KEWAUNEE NUCLEAR POWER PLANT

AMENDMENT TO FACILITY OPERATING LICENSE

Amendment No. 17
License No. DPR-43

ATTACHMENT TO LICENSE AMENDMENT NO. 17

Figure TS 3.1-1

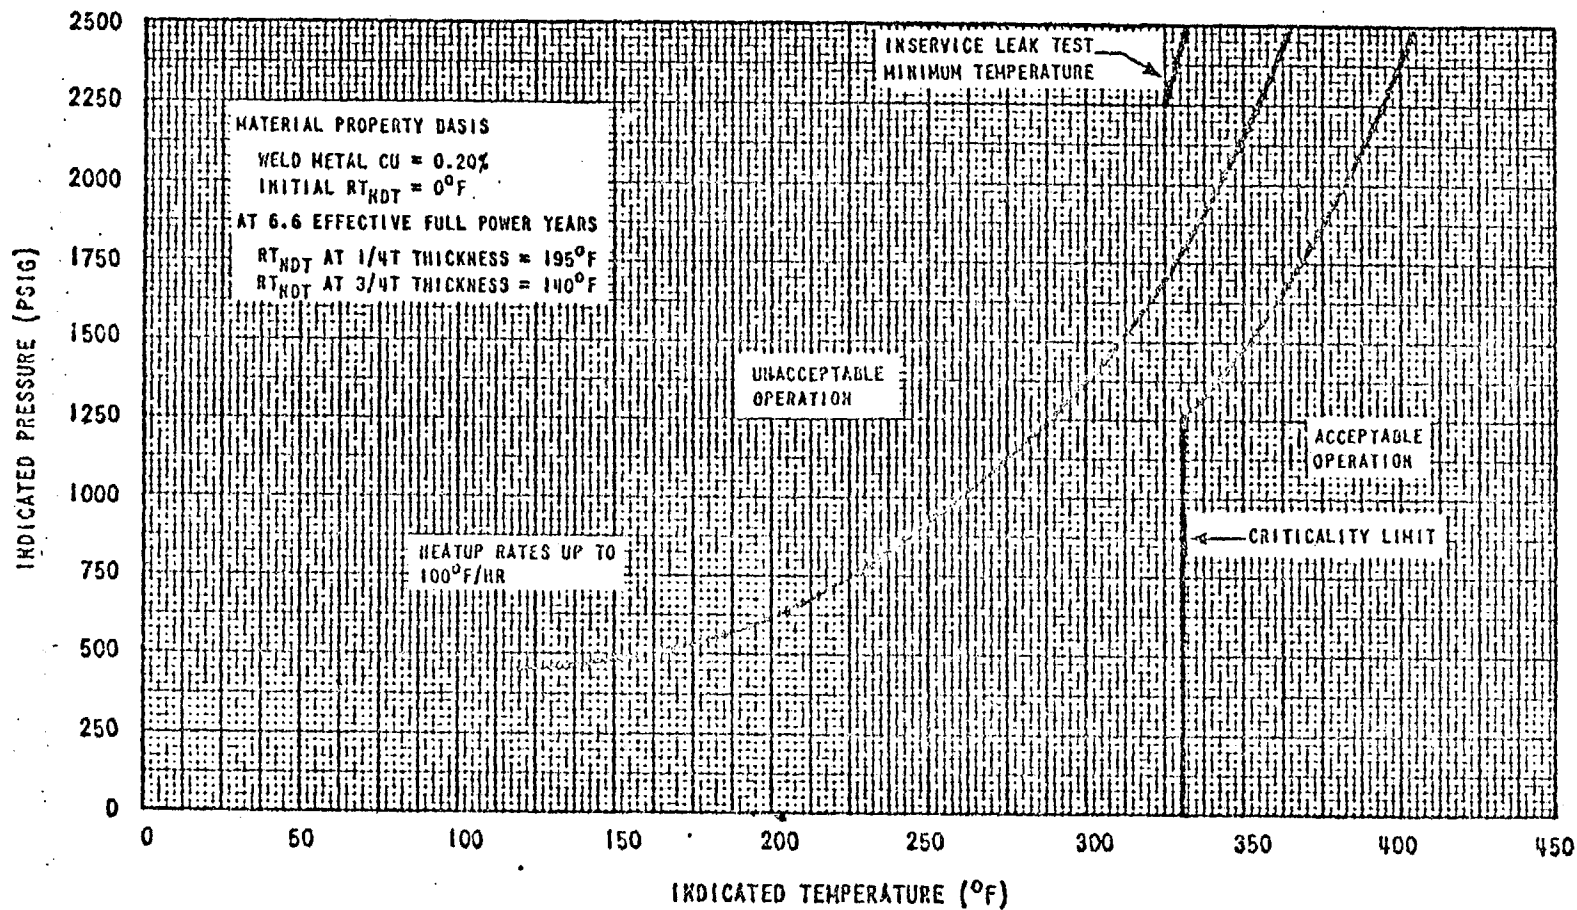
1. The reactor coolant temperature and pressure and system heatup and cooldown rates (with the exception of the pressurizer) shall be limited in accordance with Figures TS 3.1-1 and TS 3.1-2 for the service period up to 6.6 equivalent fullpower years.

- b. Figures TS 3.1-1 and TS 3.1-2 define limits to assure prevention of non-ductile failure only. For normal operation other inherent plant characteristics, e.g., pump heat addition and pressurizer heater capacity may limit the heatup and cooldown rates that can be achieved over certain pressure-temperature ranges.

Transition temperature shifts occurring in the pressure vessel materials due to radiation exposure have been obtained directly from the reactor pressure vessel surveillance program. Weld metal Charpy test specimens from Capsule V indicate that the core region weld metal exhibits the largest shift in RT_{NDT} (195°F). The capsule experienced an equivalent dose of 6.6 effective fullpower years presented in WCAP 8908.

The results of the first Irradiation Capsule analysis are presented in WCAP 8908. Heatup and cooldown limit curves for normal operation of the reactor vessel are presented in Figures TS 3.1-1 and TS 3.1-2 and represent an operational time period of 6.6 effective fullpower years.

The Kewaunee Nuclear Power Plant pressure-temperature operating limit curves, Figures TS 3.1-1 and TS 3.1-2 of the Technical Specifications were derived using the test results obtained from surveillance Capsule V. The test results were reported and analyzed in Westinghouse report WCAP-8908. The pressure-temperature operating limits were derived in accordance with Appendix G, ASME Code Section III and WCAP-7924, and are valid for operation through 6.6 EFPY.

We have reviewed the proposed pressure-temperature operating limits for Kewaunee and conclude that they are in conformance with Appendix G, 10 CFR 50 through 6.6 EFPY; such conformance, in establishing these limits will ensure adequate safety margins during operation, testing, maintenance and postulated accident conditions and constitutes an acceptable basis for satisfying the requirements of General Design Criteria 31, Appendix A, 10 CFR 50. We conclude these changes to the Technical Specifications are acceptable.

Figure TS 3.1-2

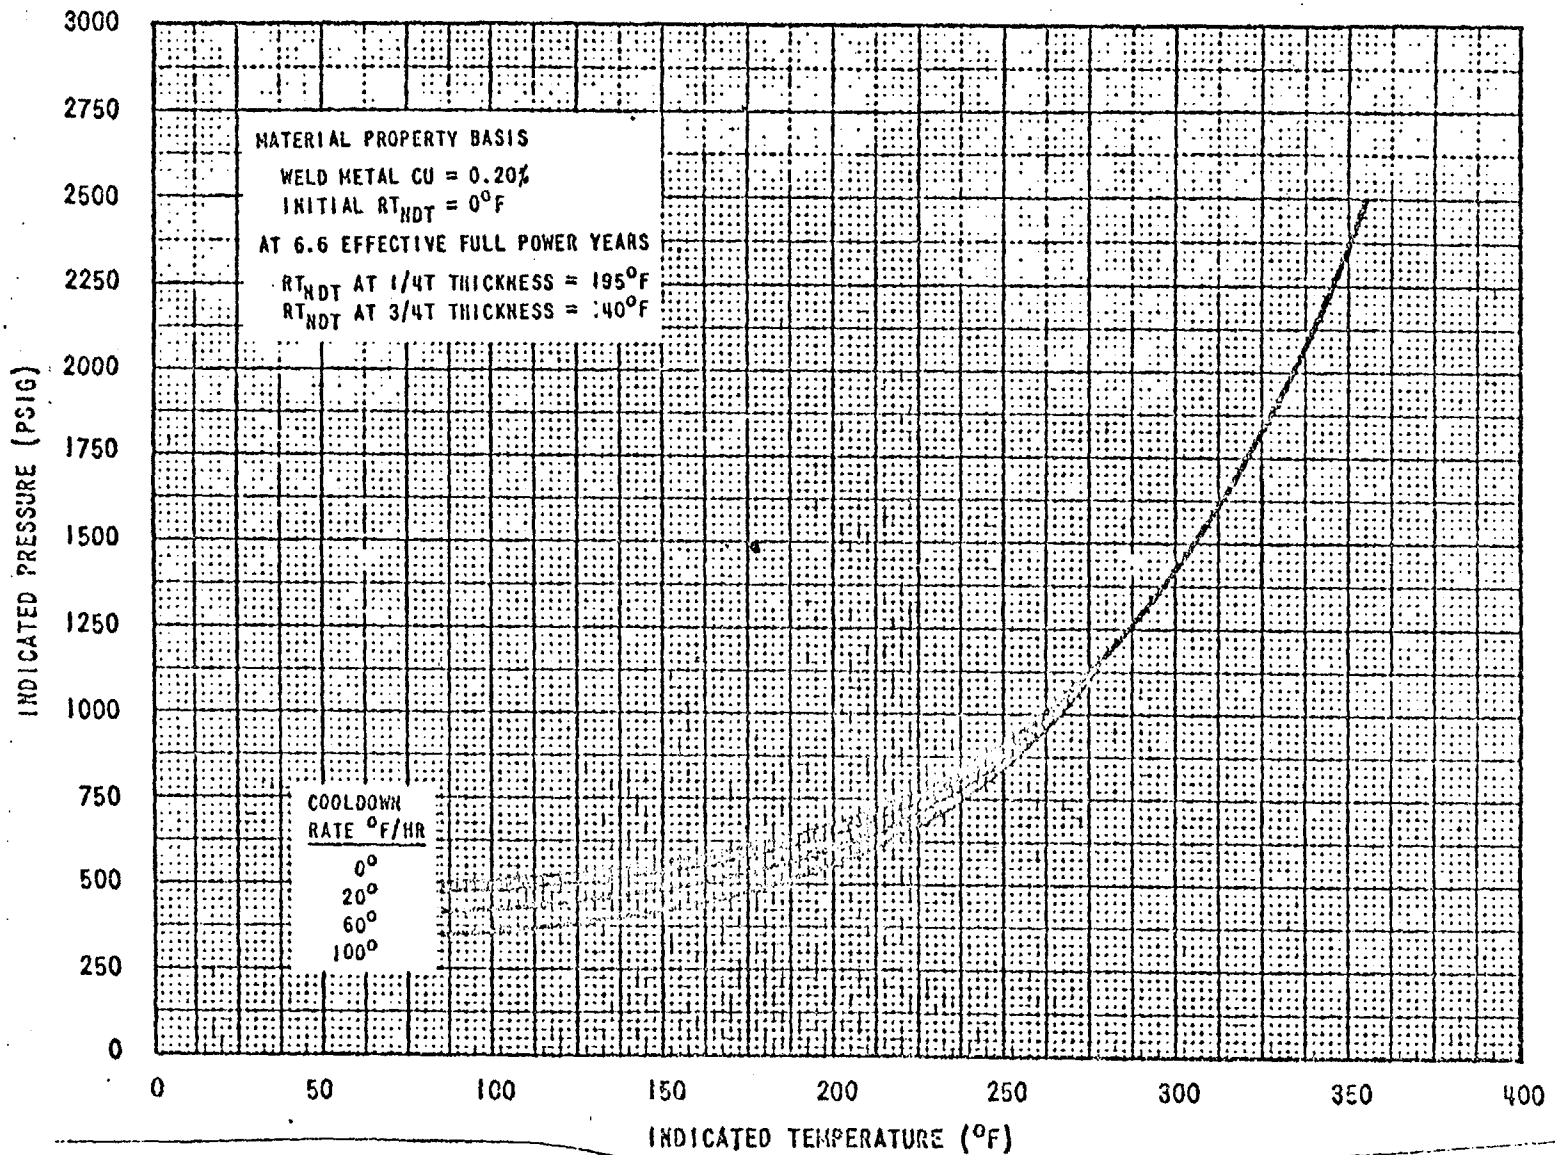
As in the case of heatup, allowable pressure-temperature relations are generated for both steady-state and finite cooldown rate situations. Composite limit curves are then constructed for each cooldown rate of interest. Again adjustments are made to account for pressure and temperature instrumentation error.
